| Project | IEEE 802.16 Broadband Wireless Access Working Group < http://ieee802.org/16 > | |
| Title | MS CDMA-based BR in Non-transparent RS System under Centralized Scheduling | |
| Abstract | This contribution proposes text modification on 6.3.6.7.2.1 of the baseline working document IEEE 802.16j-06/026r2 | |

[Figure <XXX> BW request/allocation signaling in centralized scheduling](#)

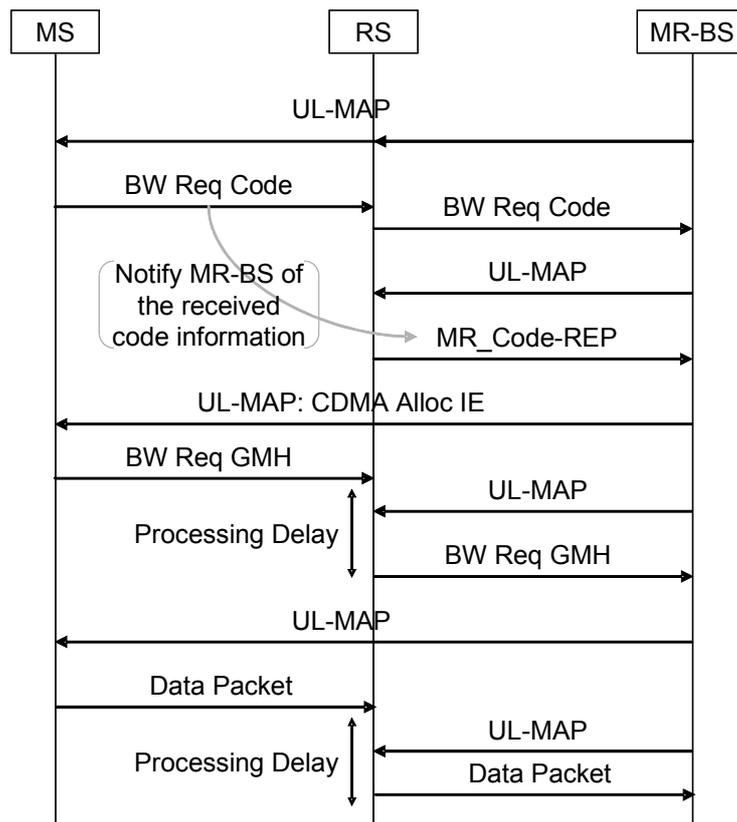
Add the following sentence and Figure after the second sentence of the third paragraph in 6.3.6.7.2.1

Thus, when an RS receives a BW request CDMA ranging code from one of its SSs, it shall send the appropriate RS CDMA ranging code toward the MR-BS indicating that one of its SSs is requesting to forward a BW request header to the MR-BS. When an intermediate RS along the path to the MR-BS receives an RS CDMA ranging code, it shall simply relay this code in the uplink direction. Upon receiving an RS CMDA ranging code, the MR-BS shall respond by ~~creating the appropriate downlink and uplink allocations~~ allocating uplink bandwidth to each RS along the relay path from the RS specified by the code for the purpose of forwarding an MR_Code-REP message containing information about the CDMA ranging code received from the SS. The MR-BS shall use the CMDA ranging code and transmit region information in the MR_Code-REP to create a CDMA_allocation_IE that allocates bandwidth on which the SS can forward a BW request header to the MR-BS. Please see the figure <XXX>.
